SERVICE BULLETIN

To: _____
From: Rich Mascolo
Fax: +1 (732) 842-1114
Company: _____
Voice: +1 (732) 842-9898 235
Subject: MaxFlight Safety Service Bulletin 2000-00
Sent: 4/13/00 at 5:30:00 PM
Pages: 1 (including cover)

Purpose: To ensure security of both Pitch and Roll Encoders

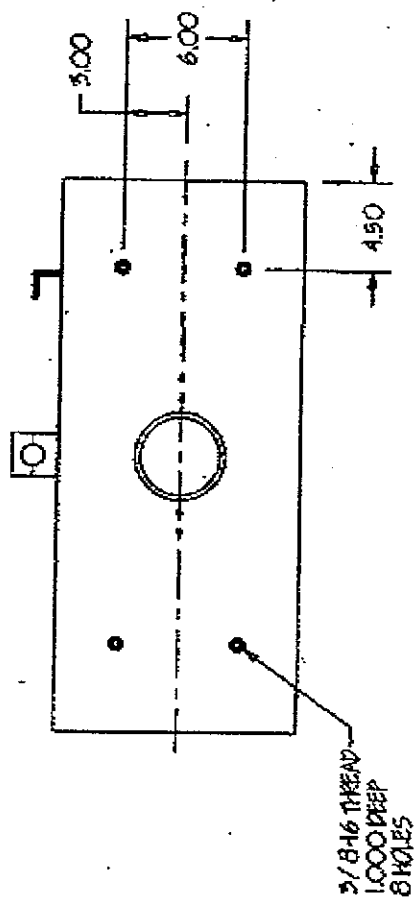
- Locate the two set screws on the pitch encoder collar, remove and re-install using Blue Loc-Tite and ensure that the screws are tightened firmly.
- Locate the one set screw on the roll motor encoder shaft collar, remove and re-install using Blue Loc-Tite and ensure that the screw is tightened firmly.

We have made it a weekly requirement to inspect both encoders for security and set screws for tightness. Please add this requirement to your present weekly inspection.
